**ADDENDUM NO. 2**

**INTERSTATE ROUTE H-1 SEISMIC RETROFIT  
PALI INTERCHANGE AND NUUANU SEPARATION**

**FEDERAL-AID INTERSTATE PROJECT NO. BR-H1-1(249)**

TERRITORIAL HIGHWAY DEPARTMENT  
 DIVISION OF HIGHWAYS  
 NULUANU HIGHWAY  
 PROJECT NO. SH-0611(16), UNIT 4  
 GRADE SEPARATION NEAR  
 SCHOOL STREET  
 LOCATION PLAN & BORINGS

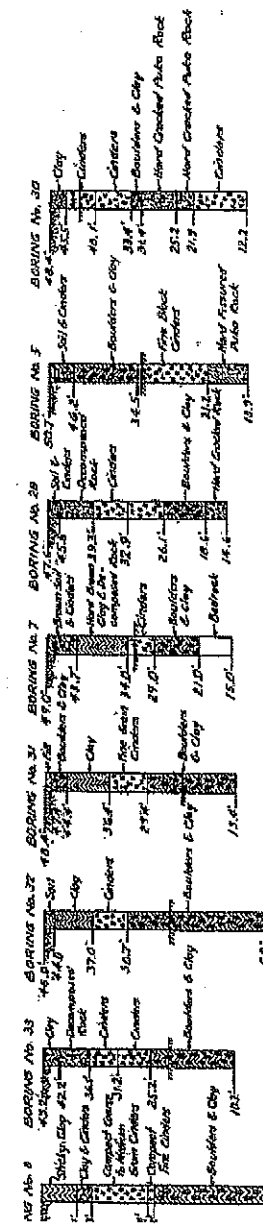
27. On sheet S6 of 22, the foundation plan is provided along with the location of the borings performed as part of the geotechnical investigation. Two of the three borings are located close to the proposed new pier, while the third is in the vicinity of (80 feet away) Abutment #2. No borings are located near Abutment #1. The question is what subsurface interpretation are the micropile contractors expected to use to estimate the drilling conditions at Abutment #1? B-1 is the closest boring and it is approximately 160 feet away. The question is the same for Abutment #2.
